Commonwealth Edison
One First National Plaza, Chicago, Illinois
Address Reply to: Post Office Box 767
Chicago, Illinois 60690 - 0767

May 31, 1988

Subject: Quad Cities Station Unit 1
Response to Request for Additional
Information (RAI) Regarding Fall
1987 Unit 1 Intergranular Stress
Corrosion Cracking (IGSCC) Inspection
NRC Docket No. 50-254

WELD OVERLAY DATA SHEET REV. 1

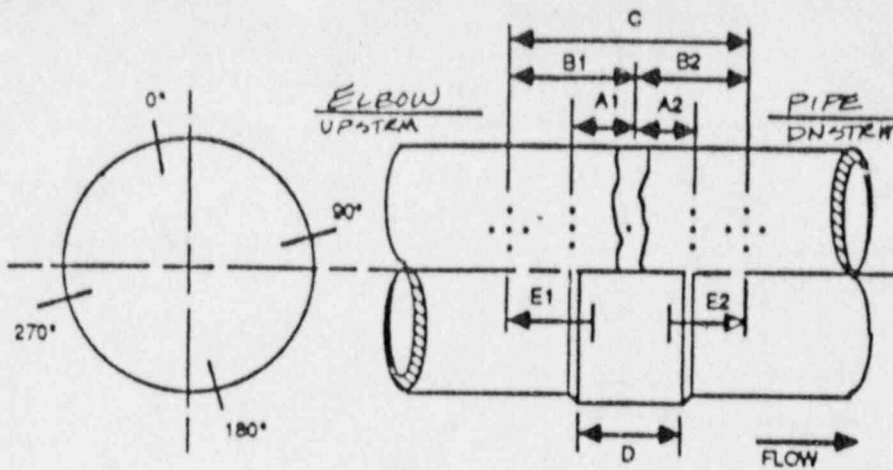
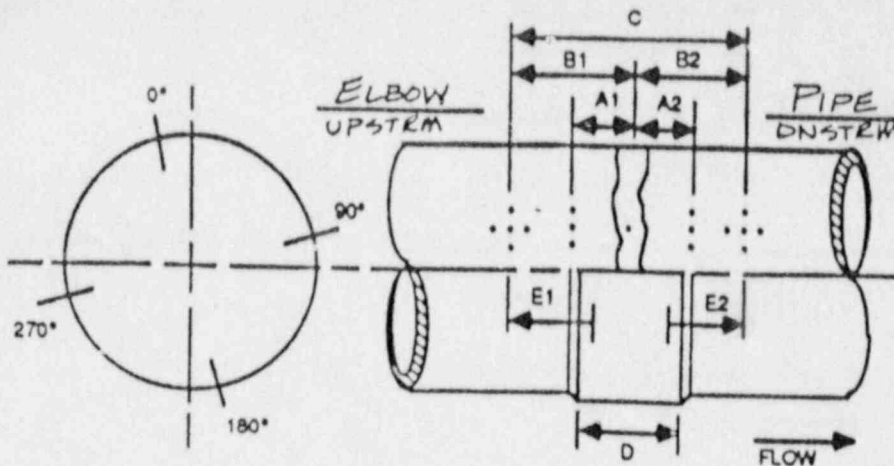
Item 6: The corrections in Table 5.2-1 and 5.2-2 result in Weld O2G-S3 having a final overlay repair thickness slightly below a NUREG-0313, Revision 2 "standard" overlay thickness. As shown in attached NUTECH Drawing CEC073.0133 and its associated Weld Overlay Data Sheet, the surface conditioning grinding of Weld O2G-S3 resulted in a final overlay thickness (0.229") below NUTECH's requested full-structural (standard) thickness (0.24"). Due to the heavy outage duration pressures caused by unplanned overlays during the Quad Cities Unit 1 1987 outage, this overlay was left as-is eventhough it was clearly below NUTECH's requested design thickness. During the rush to support an expedited final report submittal date, the data entry errors made in Tables 5.2-1 and 5.2-2 hid the fact that Weld O2G-S3 did not meet "standard" overlay criteria.

As stated in Section 5.2 of the revised flaw disposition report, the decision to leave the overlay is appropriate for the following reasons:

- a. The predicted flaw depth ratio of 0.77 can be shown to meet "standard overlay repair thickness criteria using the alternate flaw evaluation requirements of ASME Section XI Paragraph IWB-3642,

- b. Because only 0.03" of additional thickness is required to meet the arbitrary maximum allowable flaw depth ratio of 0.75 in Table IWB-3641-1, the man-REM exposure that would be expended to build up, surface condition, and reinspect the overlay cannot be justified, and

- c. Because the predicted flaw depth ratio is based upon the assumption that an IGSCC indication could eventually propagate through the 0.15" thick low delta ferrite first layer, but actual observed circumferential flaws have not been detected in the outer 25% of the original pipe wall and axial flaws have not been detected in the overlay, the inspection frequency associated with a "standard" overlay in NUREG-0313, Revision 2 Category E is sufficient.

It should also be noted that NUTECH's requested design thickness for weld O2G-S3 of 0.24" provides a "standard" thickness over a low delta ferrite first layer with a "normal" average thickness of 0.10" instead of the actual first layer thickness of 0.15". As demomnstrated by the first layer thicknesses for Welds O2C-S4, O2F-S4, and O2B-S7 in Table 5.2-1, 0.10" is a reasonable assumption for a first layer thickness, but did not provide for a conservative "standard" thickness for Weld O2G-S3 in spite of the 0.229" thickness provided by the welding contractor.

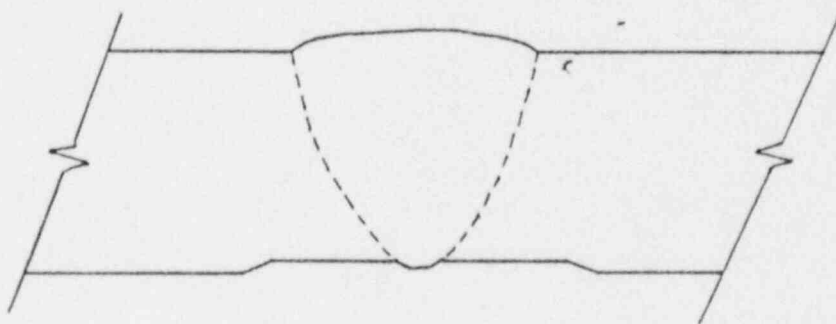
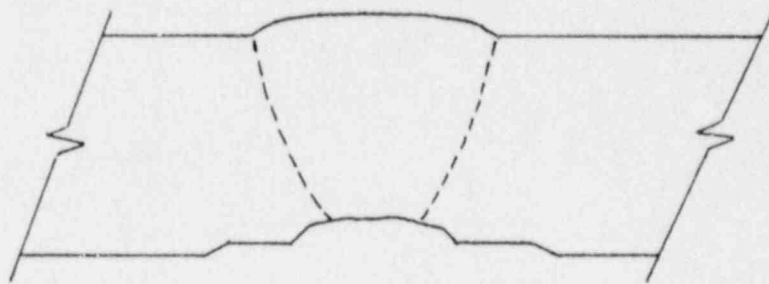
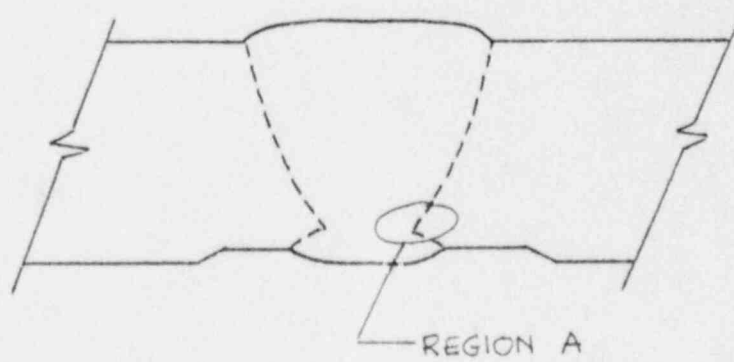
The metallographic examinations did reveal though that the welds were "backwelded," that is root of the weld was welded from the inside of the pipe. The fabrication sequences is illustrated as follows:

- The weld joint was fit-up and welded in the normal manner from the outside of the component.

- The weld root was excavated from the component ID.

- The excavation was then re-welded from the inside and ground in preparation for examination.

The "corner" created in Region A of the above sketch provides the conditions necessary to produce an ultrasonic reflector or signal (similar to a crack tip) in a region of the weldment (heat affected zone) where IGSCC is commonly seen during typical shear wave examinations.

Since 1983, ultrasonic examinations have continued to identify the signals from welds believed to have this geometric condition. No significant changes have been observed in the large majority of these weldments, thereby evidencing the geometric nature of the ultrasonic signals. Recent automated ultrasonic examinations have evaluated the signals from these locations as geometric reflectors.
